**Re: Preliminary Plat and Site Plan Review
Seasons of Ramsey**

**CITY OF RAMSEY LAND USE APPLICATION
TECHNICAL REVIEW FILE**

DATE	1/25/13	PROJECT ADDRESS	TBD - MULTIPLE
PROJECT TITLE	SEASONS OF RAMSEY		
ESCROW #	113355		
DEPARTMENT:	Planning Division		
TECHNICAL REVIEWER:	Name: Tim Gladhill Phone: 763-576-4308 Email: tgladhill@ci.ramsey.mn.us

DATE	01/25/13	PROJECT ADDRESS	TBD - MULTIPLE
PROJECT TITLE	THE SEASONS OF RAMSEY		
ESCROW #	113355		
DEPARTMENT:	Engineering		
TECHNICAL REVIEWER:	Name: Shane Nelson / Leonard Linton Phone: 763 433-9825/ 433-9834 Email: haengineering@ci.ramsey.mn.us/ llinton@ci.ramsey.mn.us

EXHIBIT: Previous Renderings

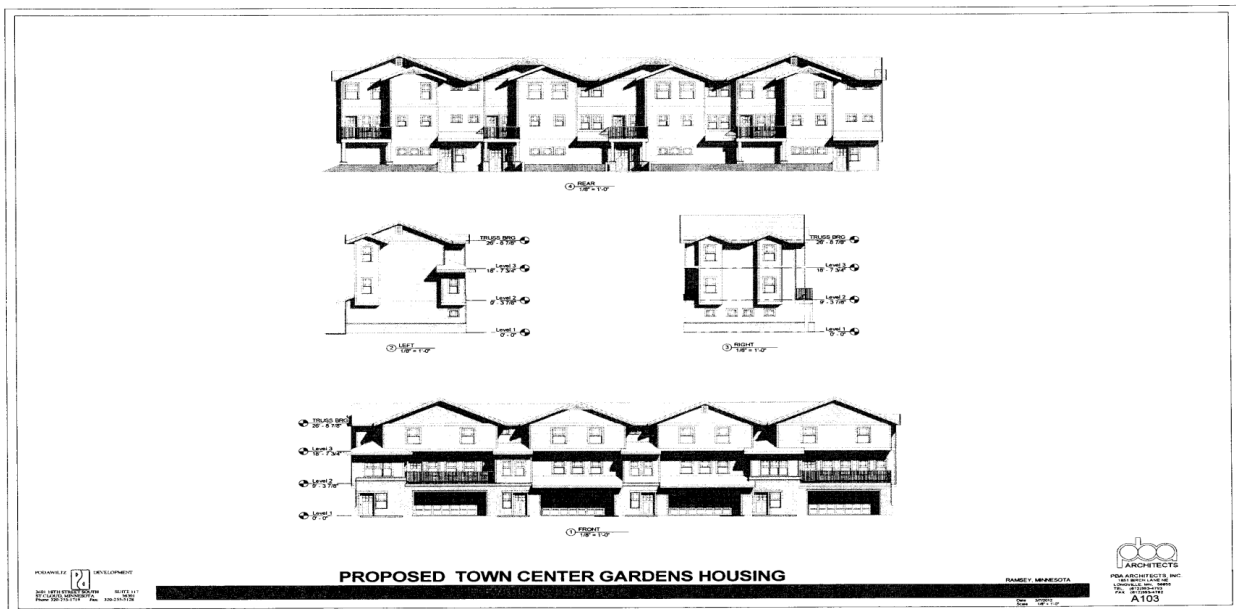
Conceptual architectural renderings were provided to the City as part of the request for a Preliminary Agreement to Develop. Said Agreement was necessary to facilitate a successful application to the Minnesota Housing Finance Agency (MHFA) for Section 42 Tax Credits. At that time, the City Council provided general feedback on architectural standards, and found that the proposed renderings were generally acceptable, but desired additional architectural elements due to the City involvement in the MHFA Application.
